ORIGINATION FORM

Proposed Revisions to a Standard Plans Index
(Please provide all information — Incomplete forms will be returned)

Index Number: 520-010
Sheet Number (s): All
Index Title: Median Opening Flume

NEW SUB SECTION: MEDIAN OPENING DETAILS

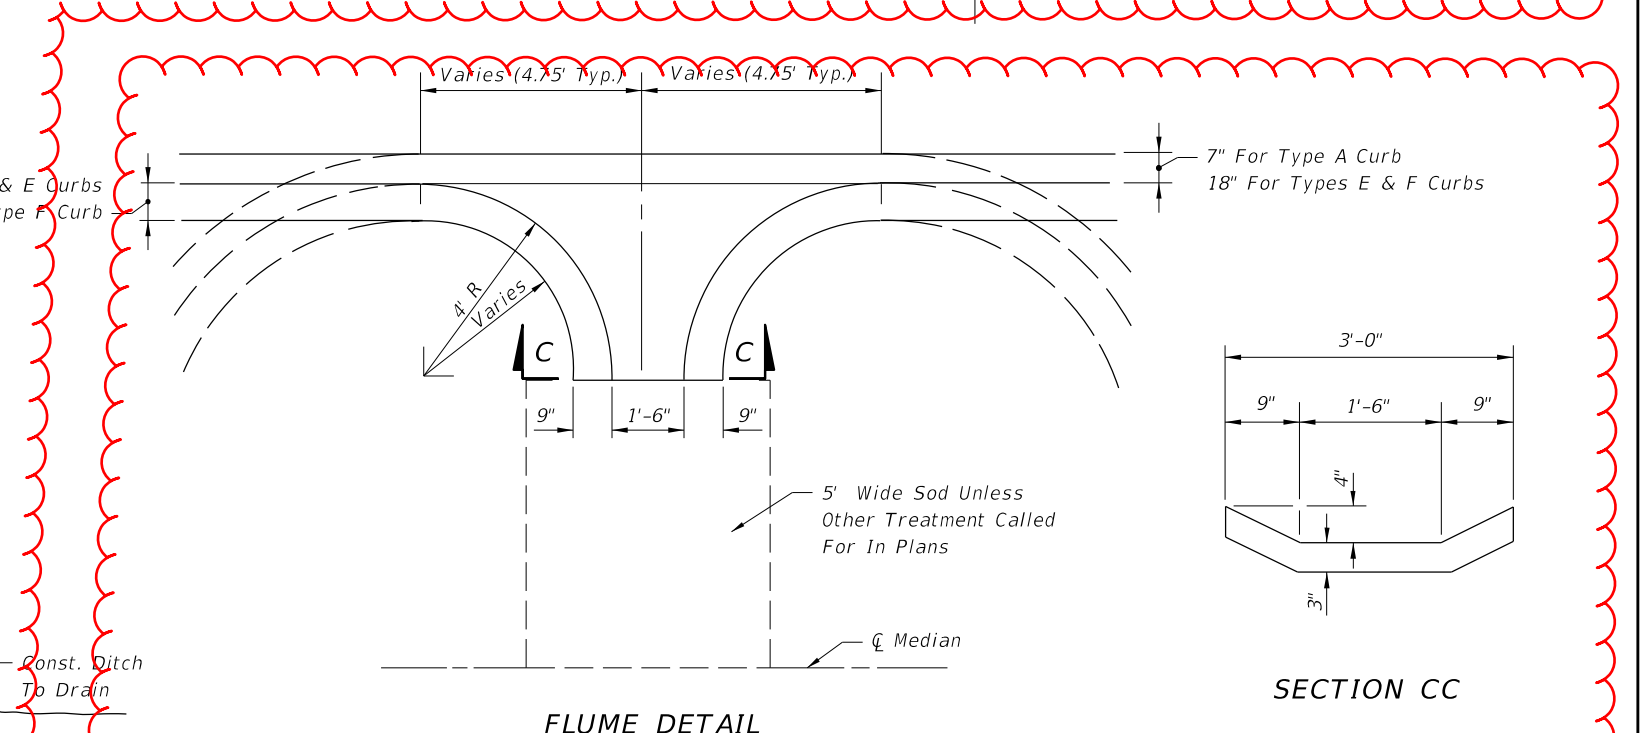
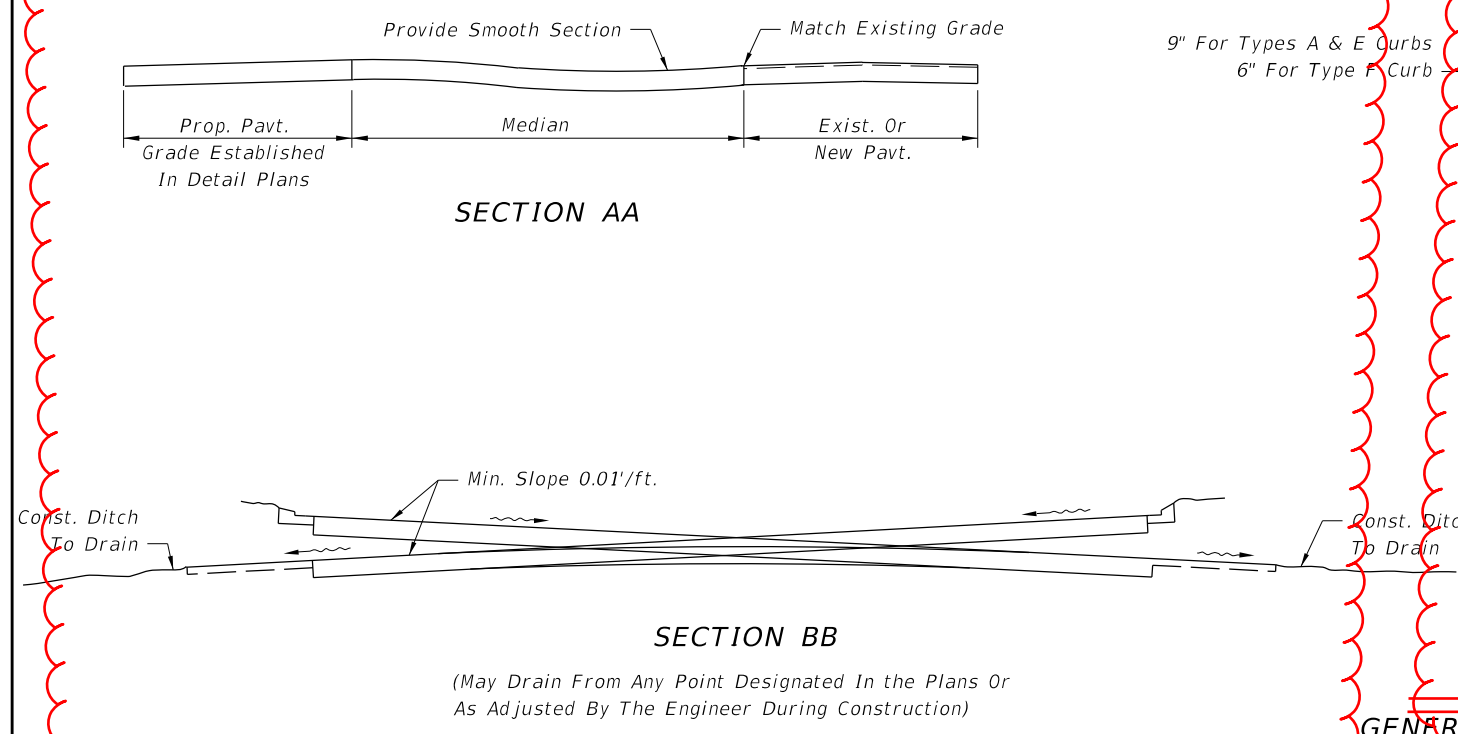
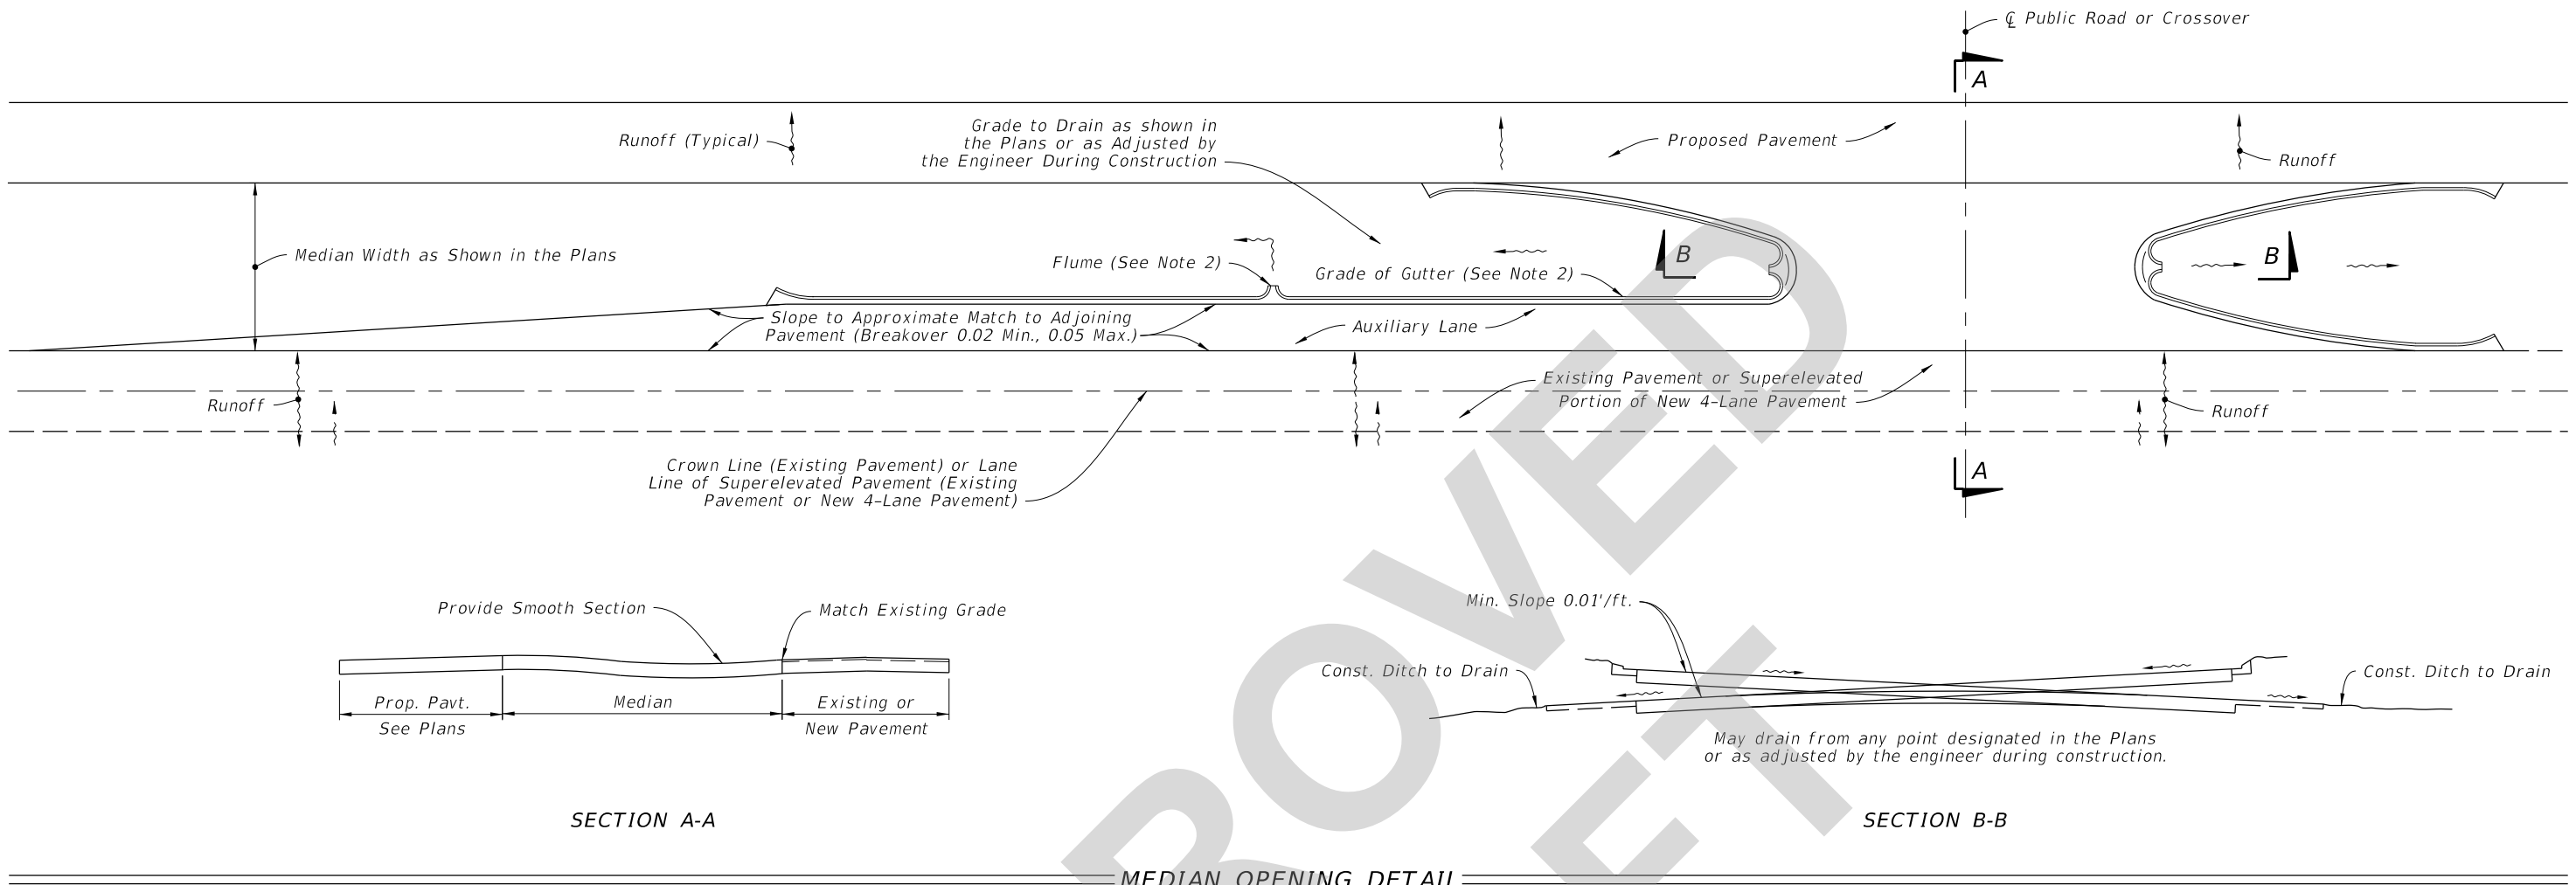
Revised and reorganized details to match other indexes. Rewrote notes and deleted pay item and design information that is now located in the SPI.

Created new Note 2

~~Provide Approximately A Minimum Of 0.20% Grade On Gutter, Slightly Warping The Surface Of The Median Pavement If Necessary, Within Limits Of The Median Curb Or Curb And Gutter. Construct A Drainage Flume Or Flumes At The Point Or Points Of Low Grade. See Details.~~

MEDIAN OPENING DETAIL

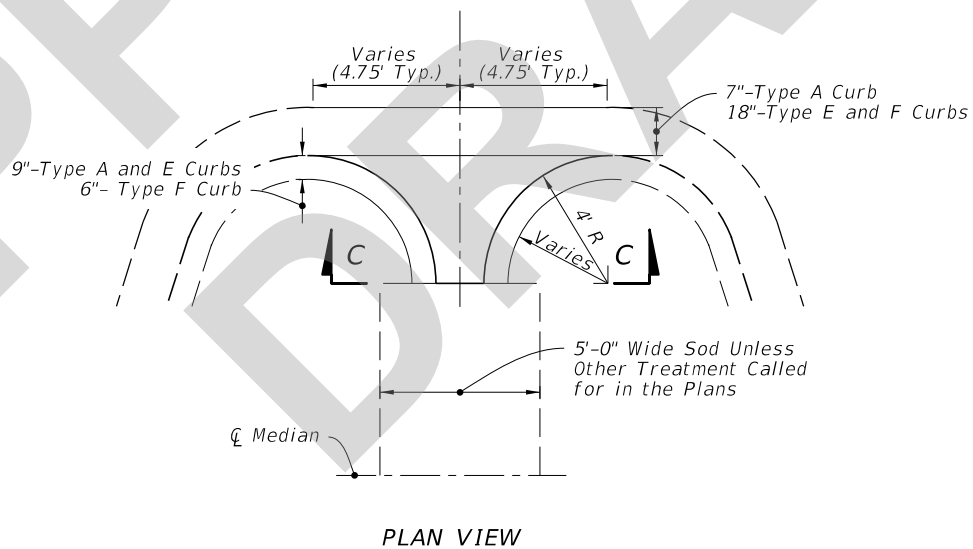
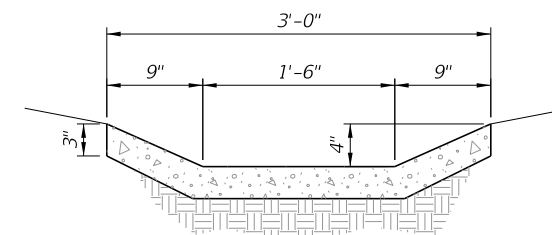
Redeveloped Index; Redrew details; Rewrote notes

1. These details are to apply to projects which provide for the conversion of 2-lane sections to 4-lane divided highway sections and for superelevated sections of new 4-lane divided highways. Layout above is illustration only.
2. See Plans for flume length and location and grade of gutter. Flume locations may be adjusted by the Engineer during construction. If necessary to provide minimum gutter grade, warp surface of the median pavement within limits of the median curb or curb and gutter.
